Recall Bulletin

PRODUCT SAFETY RECALL

SUBJECT: Roof Carrier Retaining Nut Interaction with Roof Rail Airbag

MODELS: 2015 Chevrolet Suburban, Tahoe
2015 GMC Yukon, Yukon XL

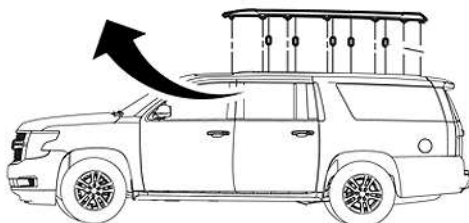
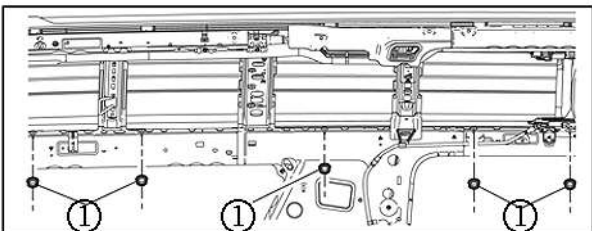
1. Remove the luggage carrier side rail retaining nuts (1) from both sides of the vehicle. Refer to *Luggage Carrier Side Rail Replacement* in SI, and only complete the underside fastener removal and install portion of the procedure.

2. Install the new luggage carrier side rail retaining nuts and caps as shown above. Refer to *Luggage Carrier Side Rail Replacement* in SI.

Dealers are to replace all of the roof carrier retaining nuts using a different type of retaining nut and adding a cap over the end of each stud.
